County Project No. SR51325 – Sunbeam Lake RV Park – Fire Incident Clean Up Project
Lot 715, Lot 716 and Lot 717; located at 1750 Drew Road, Seeley, CA 92273.

ADDENDUM NO. 4

JUNE 6, 2023

SUNBEAM LAKE RV PARK															
SITE PLAN SPACE 716

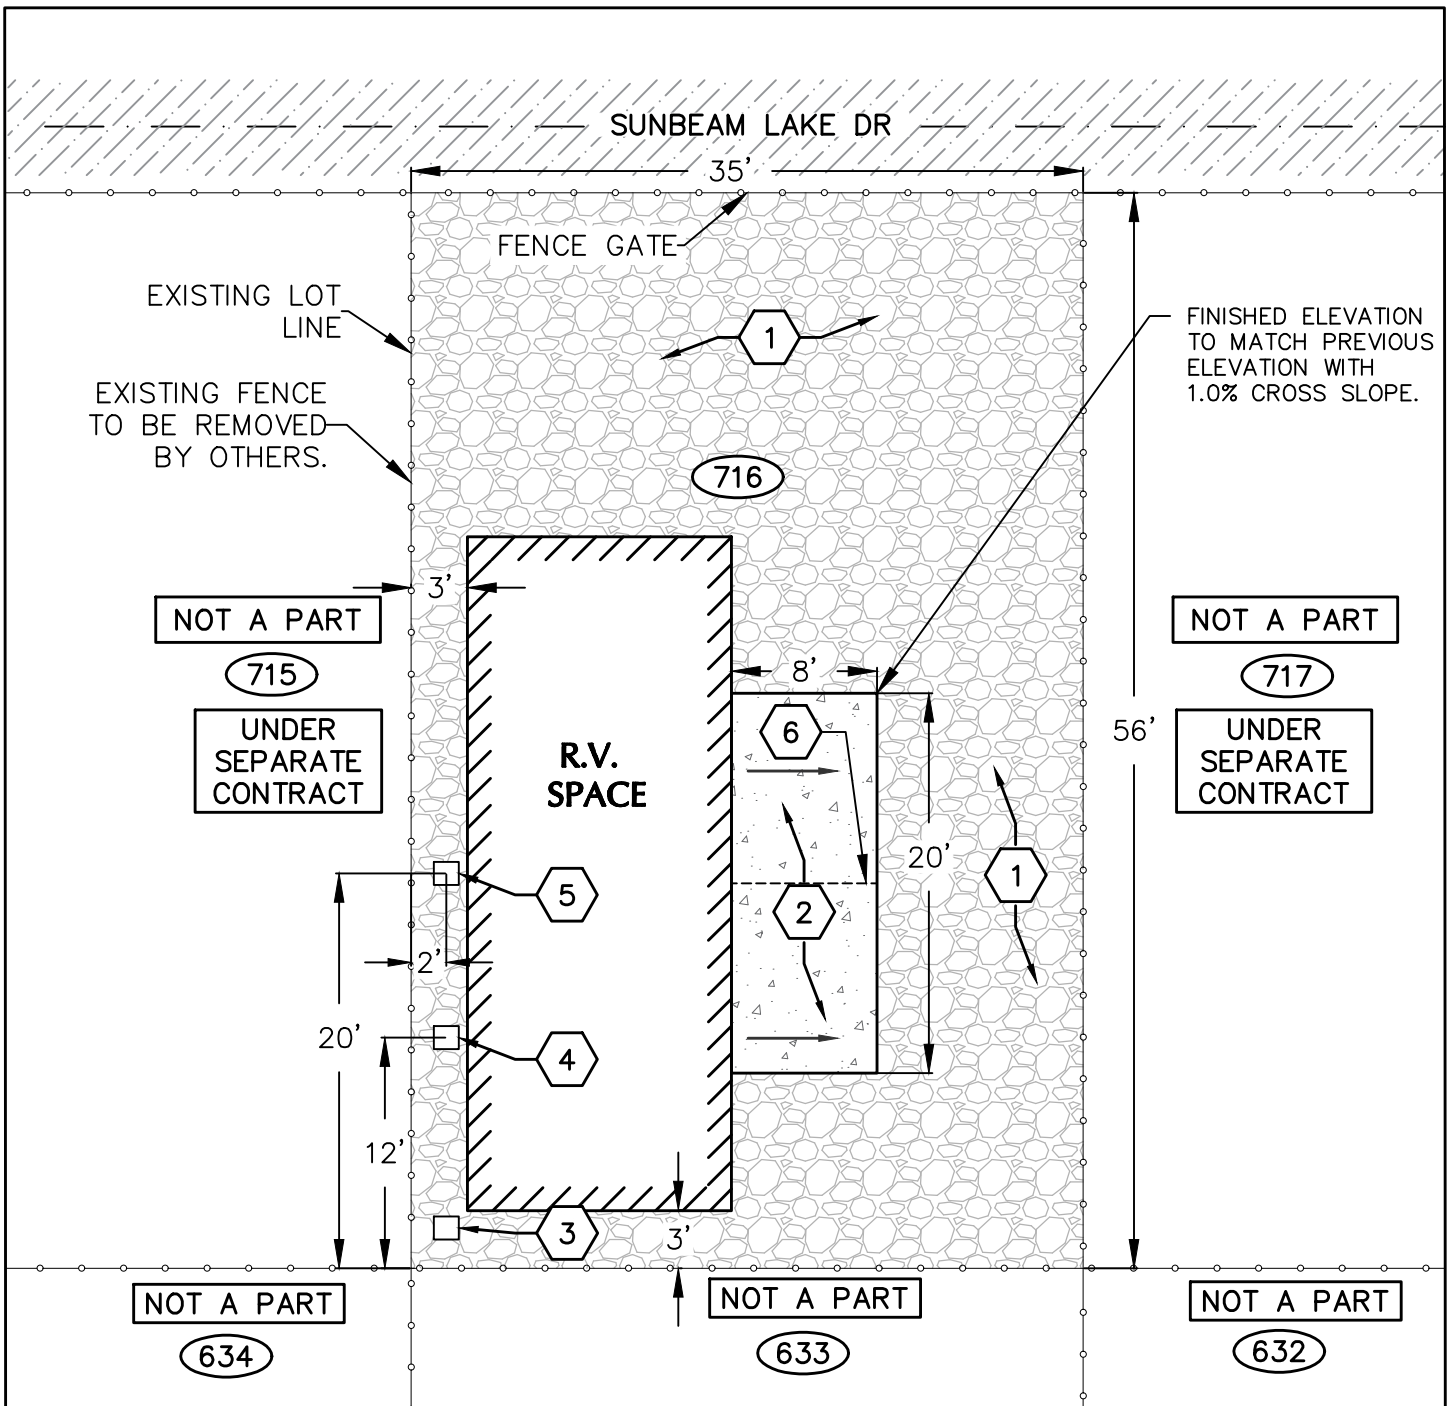
Item 1: Construction Drawings
Construction Drawings for Lot 716 and Lot 717 are revised to reflect the correct specifications on the Schedule of Work: Item No. 1. Construction Drawings for Lot 716 and Lot 717 are hereby attached.
